DEFENSE NUCLEAR FACILITIES SAFETY BOARD

August 11, 2022

Staff Report

Receipt and Repackaging of Large Amounts of Heat Source Plutonium at the Los Alamos National Laboratory Plutonium Facility

Figure 1: Schematic of the 9516 Type B package [3]

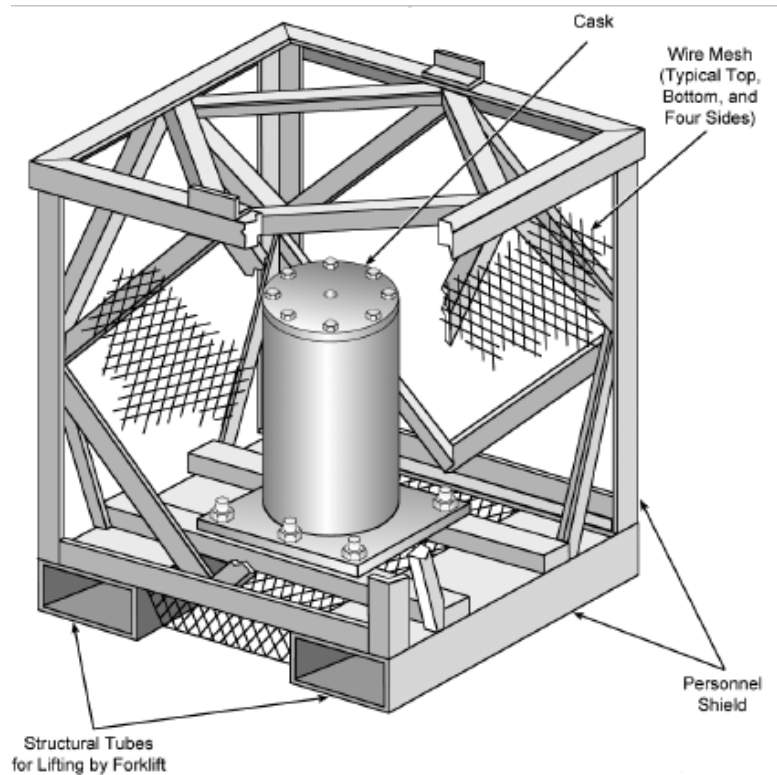
To process the material, operators will open the lid of the personnel shield, unbolt and remove the lid from the cask, and remove the containment vessel from the cask. The containment vessel is a stainless steel can “designed to remain leaktight” during hypothetical over-the-road transportation accidents involving the 9516 package [3]. The operators will cut open the containment vessel inside a fume hood and then transfer the product containers nested within to a glovebox. Operators will then perform a series of repackaging steps within various gloveboxes, culminating with packaging the HS-Pu in robust welded containers. These robust

During times when the HS-Pu is within the uncredited product containers but not overpacked in containers that are credited with a damage ratio of zero (e.g., the containment vessel), seismic events involving a fire could result in mitigated offsite dose consequences that exceed the Evaluation Guideline of 25 rem TED defined in DOE Standard 3009-2014. Depending on the assumptions used, the calculated mitigated offsite dose consequences range from 490–3175 rem TED.

The main reason for the high dose consequences is the possibility of a pressurized release from the uncredited product containers in a fire. The wide range of the calculated dose consequences is driven by uncertainty in how much airborne material will exit the building. The PF-4 safety control strategy currently relies on the building to passively confine material during an accident. The mitigation provided by the passive confinement system is quantified using a parameter known as leak path factor, which represents the fraction of airborne plutonium that escapes the building to the outside environment. Since Triad has not analyzed the leak path factor for this mission, the DSA addendum lists a range of leak path factors that might be applicable (0.16–1.0). The Board has previously communicated concerns with the existing leak path factor analysis [4, 5].

Safety considerations and mission needs drive the timeline for this mission. As the plutonium undergoes alpha decay, it produces helium, which remains within the sealed containers. If there is sufficient accumulation of helium, the containers could over-pressurize in a fire, leading to a release of plutonium. Type B packages are qualified to survive a fire scenario, but because of helium accumulation, there are time limits on this qualification for the 9516 package. The Type B packages will reach these time limits between October 2023 and May 2024, after which they will not meet safety requirements for shipping. DOE officials have asserted that INL lacks the capability to repack the containers, and therefore the shipments to LANL must be completed before the time limits elapse. Regarding mission needs, Triad personnel stated that they need to produce heat source components by 2024–2025 to support NASA's timeline.

Containment Vessel Performance—The DSA addendum assumes that the containment vessel can withstand a fire but does not support this assumption with a rigorous evaluation. The addendum focuses on glovebox fires on the grounds that a glovebox fire would expose the containment vessel to higher air temperatures than other fire scenarios. The addendum concludes that the containment vessel would withstand exposure to those air temperatures.

However, there are other potential mechanisms for heat transfer to the confinement vessel, such as radiative heat flux from the fire and flame impingement. The DSA states that it does not consider the impact of flame impingement in a glovebox fire due to the expected transient nature of the fire. However, there are no safety controls for protecting such assumptions. Further, radiative heating and flame impingement could be more important in a room fire (i.e., outside the glovebox), which would not be as oxygen-limited as glovebox fires. Thus, the evaluation would be more persuasive if it considered radiative heating and flame impingement.

The addendum also acknowledges that the containment vessel would not withstand impact from certain equipment that could fall on it but does not identify meaningful safety controls for protecting facility workers from this hazard.
